PALO VERDE NUCLEAR GENERATING STATION, UNIT NO. 1

AMENDMENT TO FACILITY OPERATING LICENSE

Amendment No. 23
License No. NPF-41

ENCLOSURE TO LICENSE AMENDMENTAMENDMENT NO. 23 TO FACILITY OPERATING LICENSE NO. NPF-41DOCKET NO. STN 50-528

FIGURE 3.1- 1A

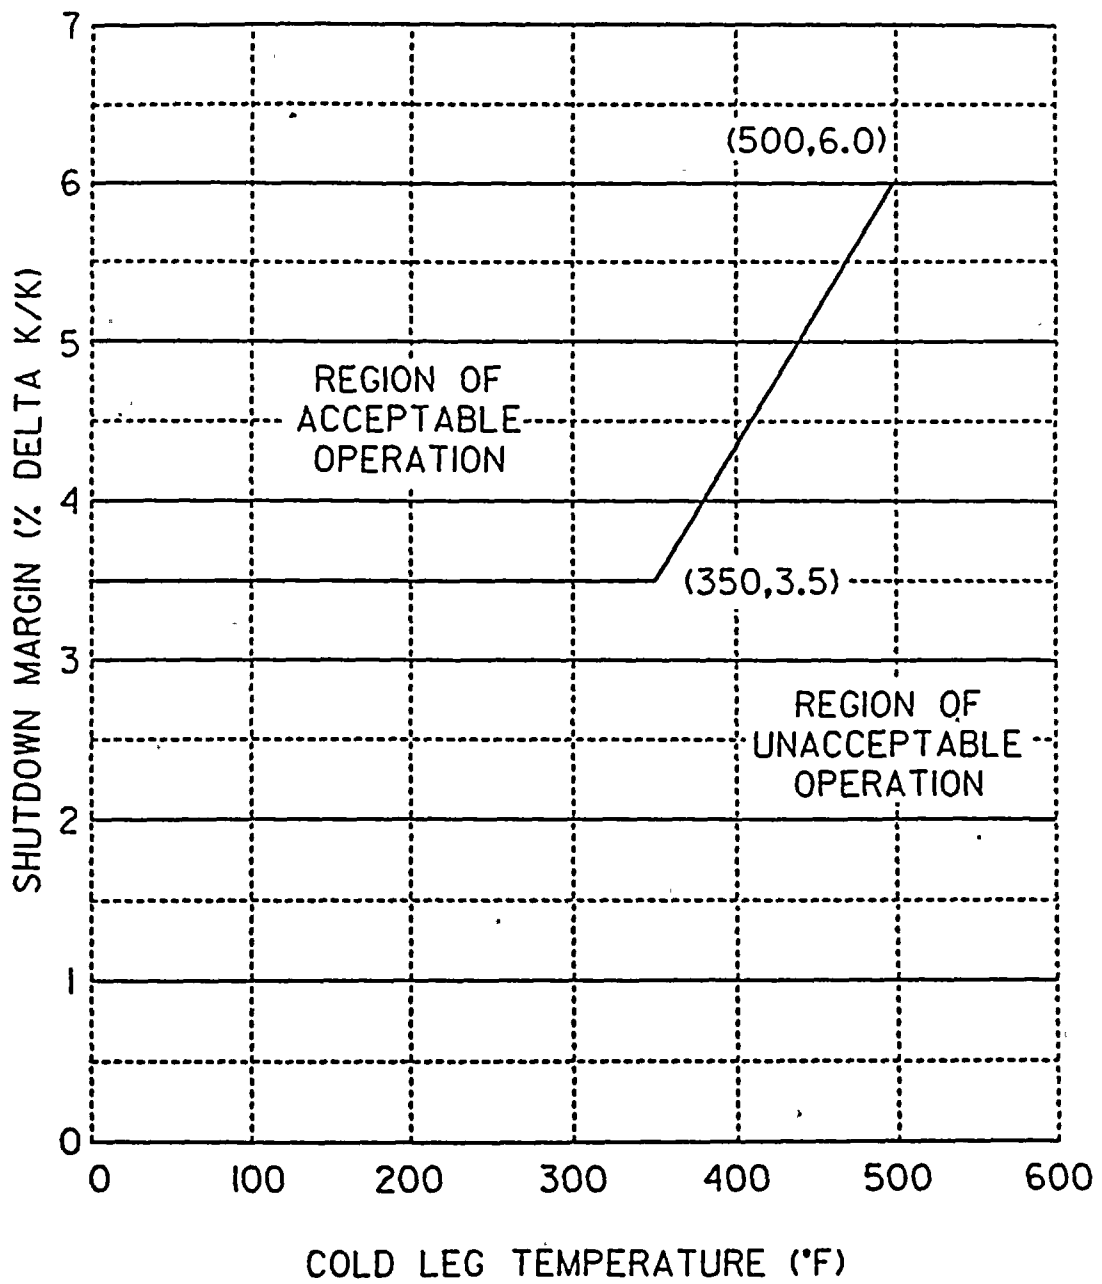
- a. The SHUTDOWN MARGIN shall be greater than or equal to that shown in Figure 3.1-1A, and
- b. For T_{cold} less than or equal to 500°F, K_{N-1} shall be less than 0.99.

- a. With the SHUTDOWN MARGIN less than that in Figure 3.1-1A, immediately initiate and continue boration at greater than or equal to 26 gpm to the reactor coolant system of a solution containing greater than or equal to 4000 ppm boron or equivalent until the required SHUTDOWN MARGIN is restored, and
- b. With T_{cold} less than or equal to 500°F and K_{N-1} greater than or equal to 0.99, immediately vary CEA positions and/or initiate and continue boration at greater than or equal to 26 gpm to the reactor coolant system of a solution containing greater than or equal to 4000 ppm boron or equivalent until the required K_{N-1} is restored.

4.1.1.2.1 With any full-length CEA fully or partially withdrawn, the SHUTDOWN MARGIN shall be determined to be greater than or equal to that in Figure 3.1.1A:

FIGURE 3.1- 1A

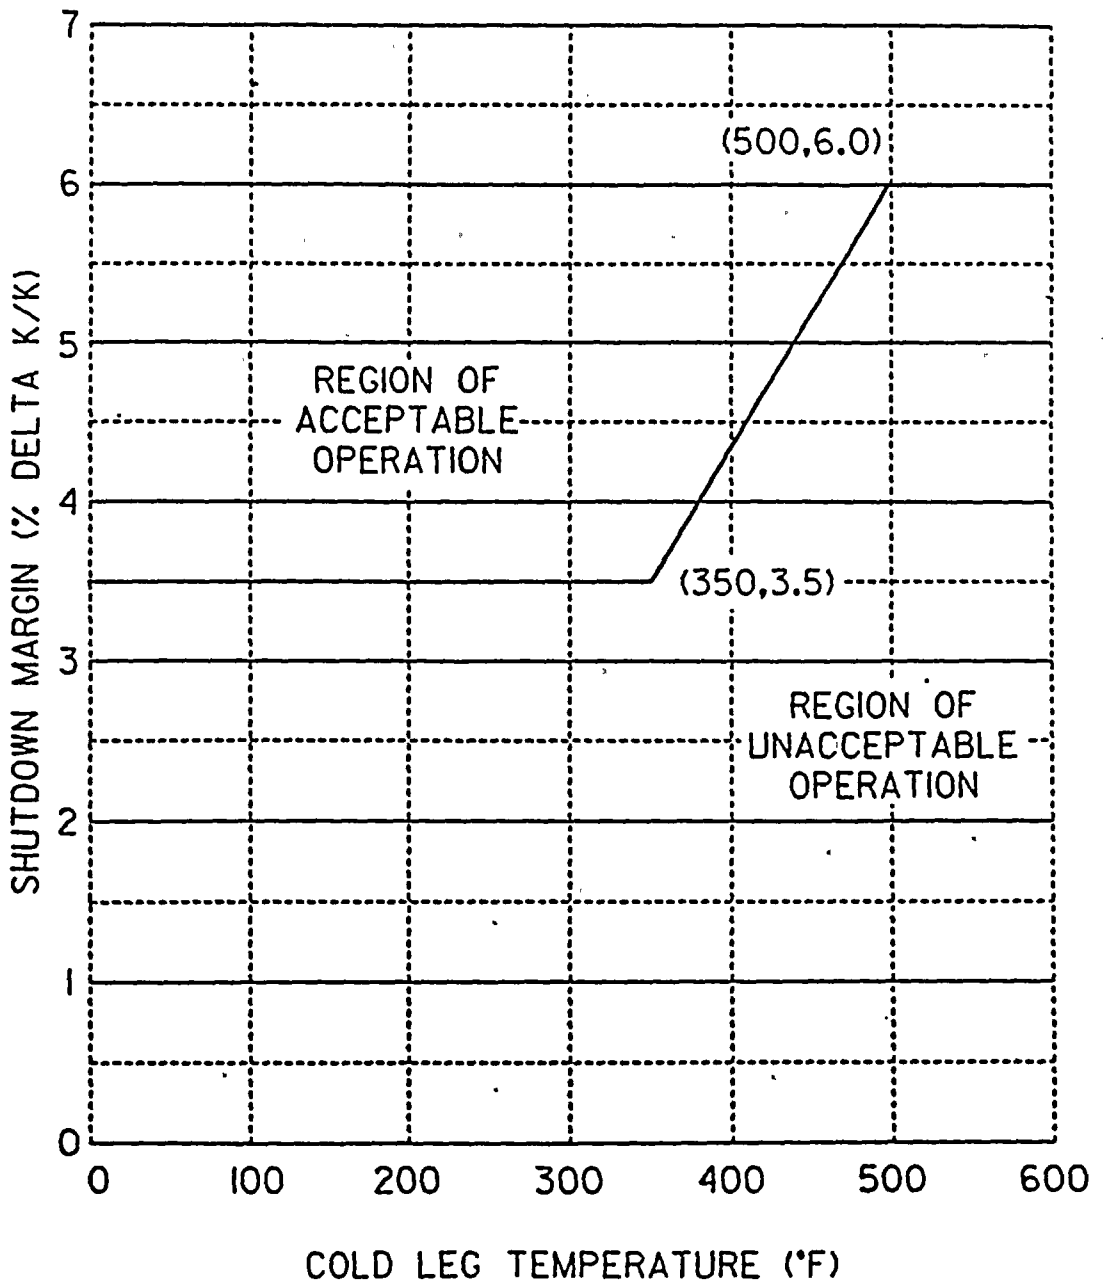
- a. The SHUTDOWN MARGIN shall be greater than or equal to that shown in Figure 3.1-1A, and
- b. For T_{cold} less than or equal to 500°F, K_{N-1} shall be less than 0.99.

- a. With the SHUTDOWN MARGIN less than that in Figure 3.1-1A, immediately initiate and continue boration at greater than or equal to 26 gpm to the reactor coolant system of a solution containing greater than or equal to 4000 ppm boron or equivalent until the required SHUTDOWN MARGIN is restored, and
- b. With T_{cold} less than or equal to 500°F and K_{N-1} greater than or equal to 0.99, immediately vary CEA positions and/or initiate and continue boration at greater than or equal to 26 gpm to the reactor coolant system of a solution containing greater than or equal to 4000 ppm boron or equivalent until the required K_{N-1} is restored.

4.1.1.2.1 With any full-length CEA fully or partially withdrawn, the SHUTDOWN MARGIN shall be determined to be greater than or equal to that in Figure 3.1.1A:
